Request for a conditional use permit to place more than 50 cubic yards of material in a shoreland impact zone for the purpose of raising an existing flood protection levee located in the Conservation and Shoreland zoned districts. The sites include Lot 1 Block 1 and Outlot D of Cedar Meadows Subdivision Number Two located in the NW Qtr of the SE Qtr of Section 18, Decoria Township.

Request for a conditional use permit to place more than 50 cubic yards of material in a shoreland impact zone.

NED RECTOR
FLOODPROOFING - 2011
GRADING/DRAINAGE PLAN

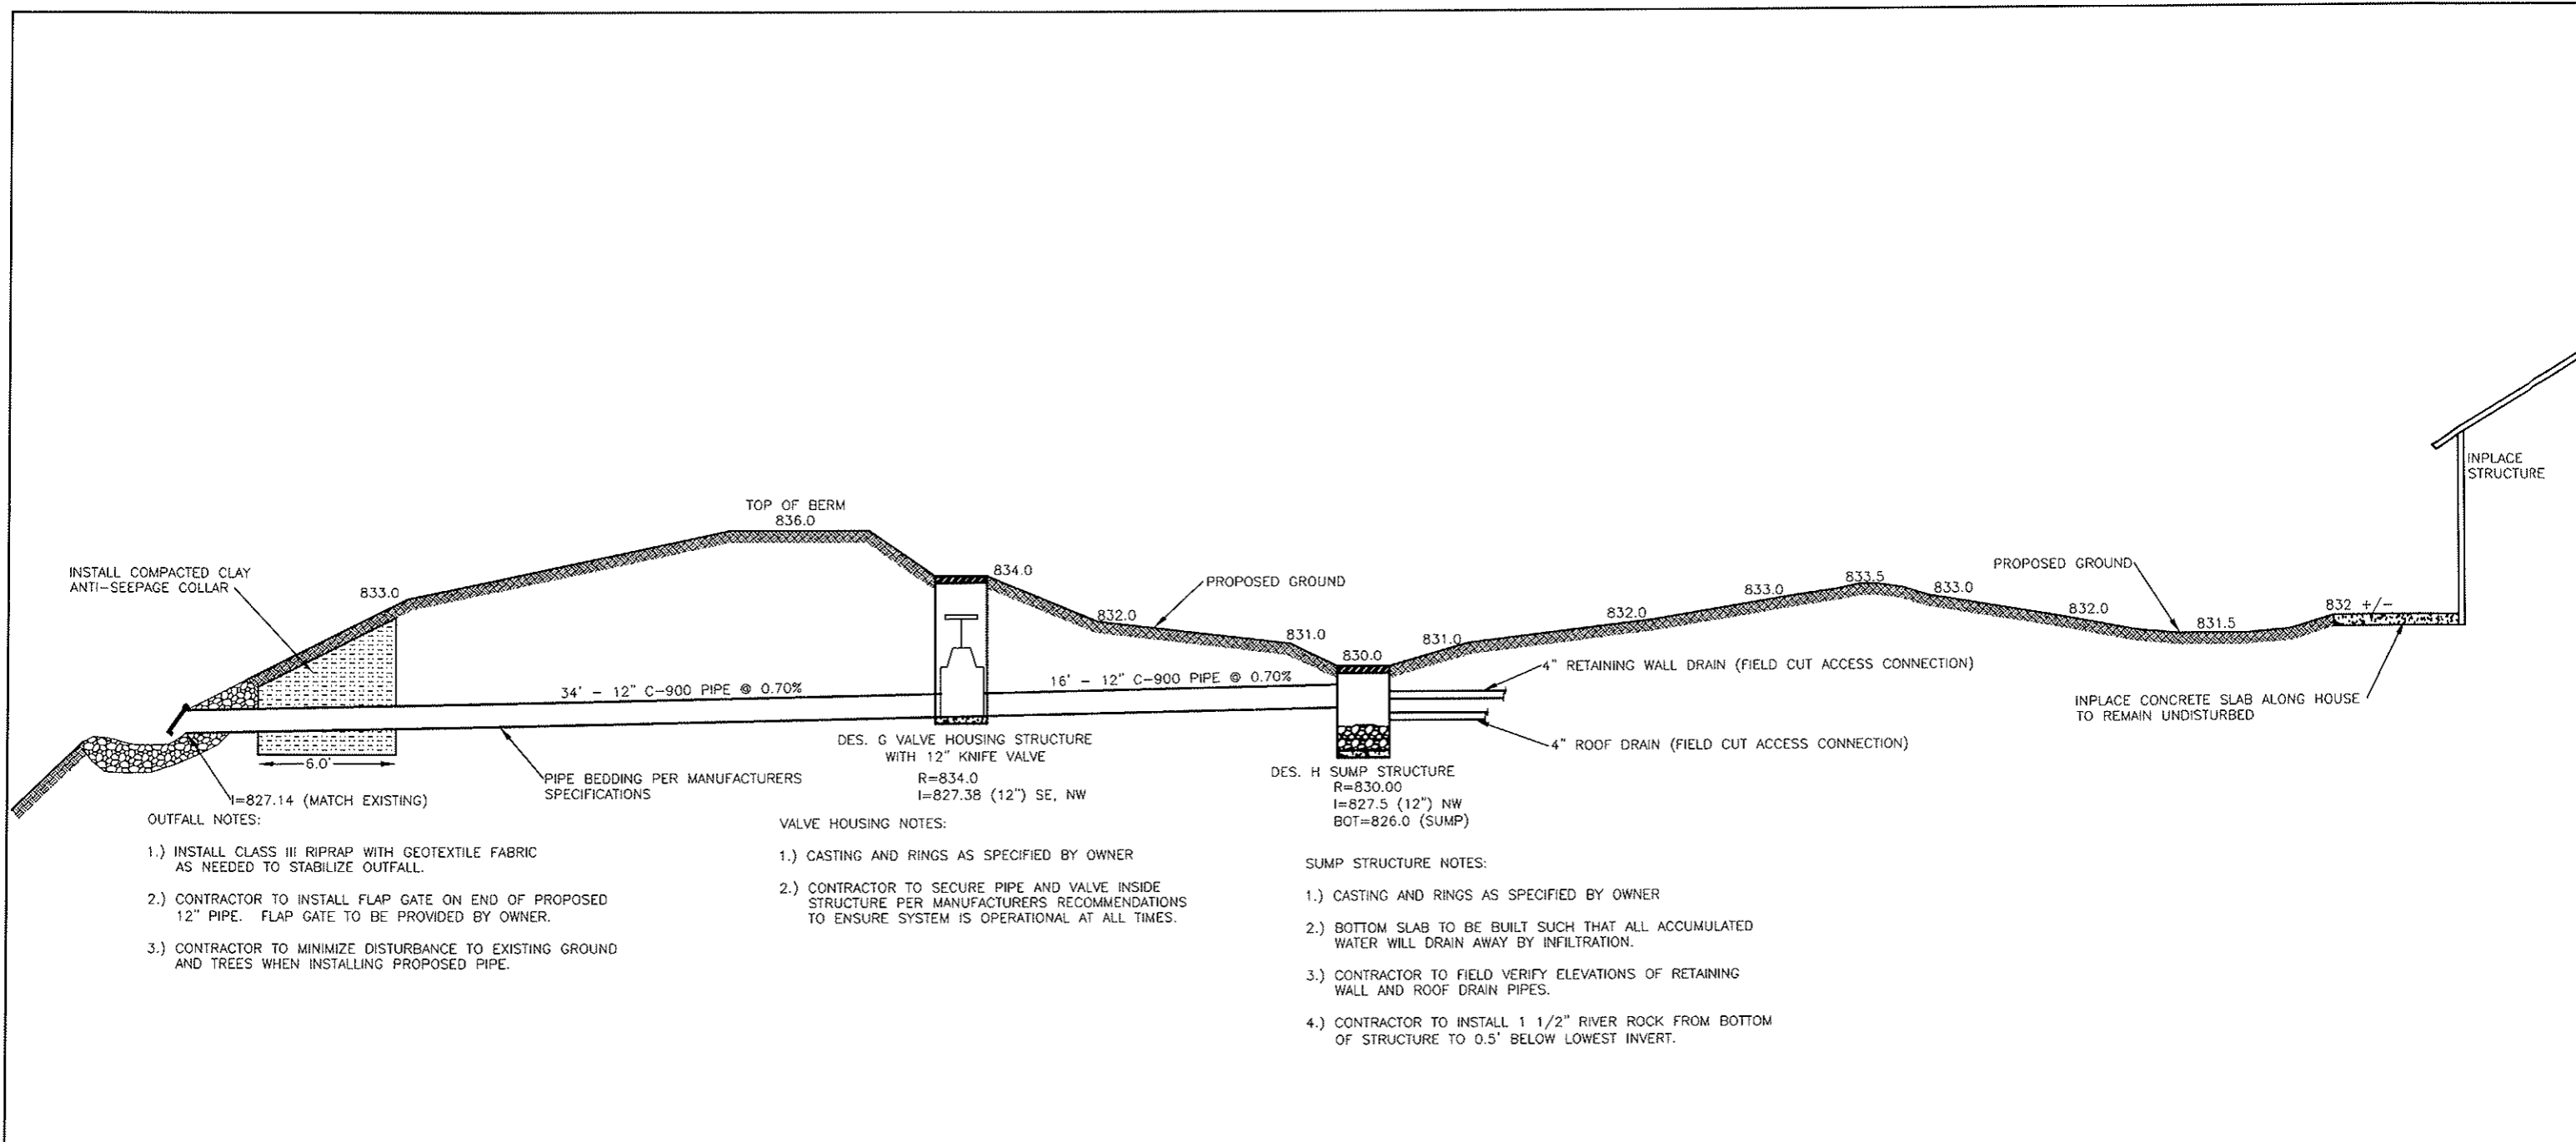
In an email dated June 23, 2011, DNR Area Hydrologist Leo Getsfried indicated the following: *Under MNDNR review I expressed no concern with the proposed fill since it will occur above the 100-year flood elevation, will not affect any sensitive areas, and the fill will be adequately stabilized with permanent vegetation.* The email also indicated that the applicant has been given permission to undertake repairs of the previously constructed riprap along the riverbank using natural rock.

Comments: Septic is compliant based on inspection 4/22/2011. Valid until 4/21/2014 All fill must be outside the 20' setbacks of the existing septic system. (P. Otterness 06/21/2011 3:15 PM)

Comments: In 2000 a new home and well, unique # 620933, were constructed on this property. The well is located just north of the NW corner of the house. The proposed dike construction does not appear to negatively impact this well. (T. Grant 06/16/2011 3:04 PM)

Comments: BEC wetland specialists met with Ned Rector onsite on June 14, 2011 to verify where the levee would be placed to ensure that it would not impact any wetlands. Bolten and Menk engineered plans for the levee and submitted the site plan to BEC via email prior to doing the site visit. The homeowner walked us all over the site explaining the proposed work and the levee will not impact any wetlands. While on the site visit it was noticed that a part of the existing driveway turnaround has fill going down into the wetland. The homeowner was asked to have that fill removed from the wetland while they are constructing the levee and then place rip rap on the slope so it will not erode any fill into the wetland in the future. (S. Feser 06/21/2011 2:30 PM)

1. That the project shall be completed prior to the end of the 2011 construction season. This shall include the final placement of fill, final grading, proper armoring (where needed), and permanent vegetation must be established.

2. That adequate erosion control is installed in all work areas susceptible to erosion prior to commencement of the project and maintained until sufficient vegetation is established. This may include, but is not limited to, temporary seeding, silt fencing, placement of fiber blanket, mulching, staked straw or hay bales etc.
